CONTRACT CHANGE ORDER NO. ____
SHEET ____ OF ____

MARK	DATE	DESCRIPTIONS	BY	CH'D	CCO#
5	08/10/11	BIKEPATH PAD REVISIONS	GB	TH	211
4	01/25/11	BIKEPATH STUD ISSUE	CC	TH	186
3	08/20/10	BIKEPATH DETAILS	TH	CC	99
2	07/07/08	CAULKING	AS	TH	66
1	07/20/07	BIKEPATH BRACKETS	GB	TH	33

SAN FRANCISCO OAKLAND BAY BRIDGE
EAST SPAN SEISMIC SAFETY PROJECT
SELF-ANCHORED SUSPENSION BRIDGE
(SUPERSTRUCTURE & TOWER)

BIKEPATH DETAILS NO. 1

ELASTOMERIC BRG PAD
1:20

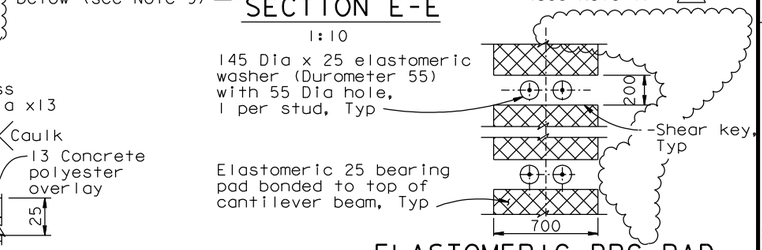
MARK	DATE	DESCRIPTIONS	BY	CH'D	CCO#
4	08/10/11	BIKEPATH PAD REVISIONS	GB	TH	211
3	02/04/11	BIKEPATH STUD ISSUE	CC	TH	186
2	08/20/10	BIKEPATH DETAILS	CC	TH	99
1	07/24/09	BIKEPATH DETAILS	CC	TH	99

ALTERNATE ELASTOMERIC BEARING PAD

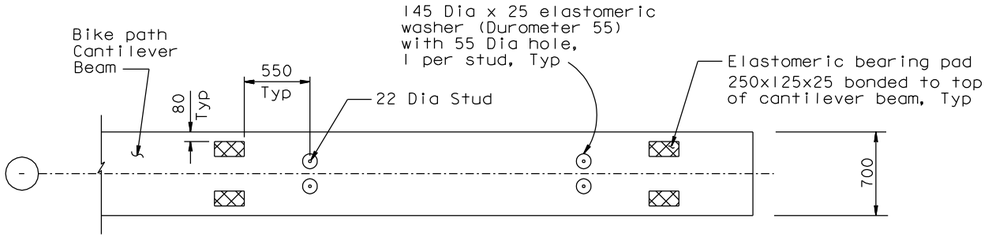
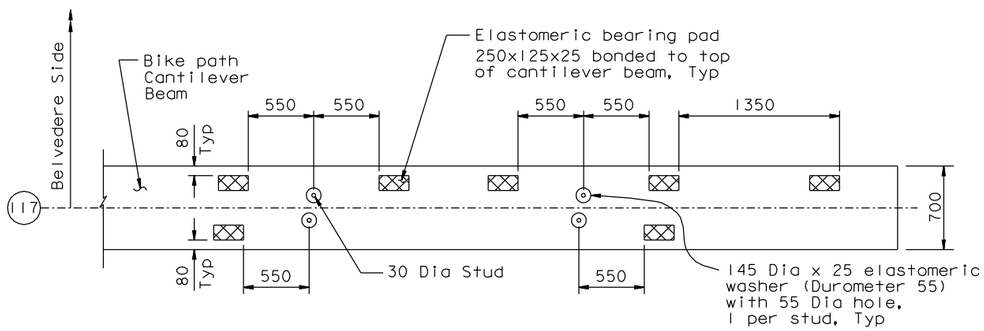
MARK	DATE	DESCRIPTIONS	BY	CH'D	CCO#
2	08/10/11	BIKEPATH PAD REVISIONS	GB	TH	211
1	01/25/11	BIKEPATH STUD ISSUE	TH	CC	186
0	08/20/10	BIKEPATH DETAILS	CC	TH	99
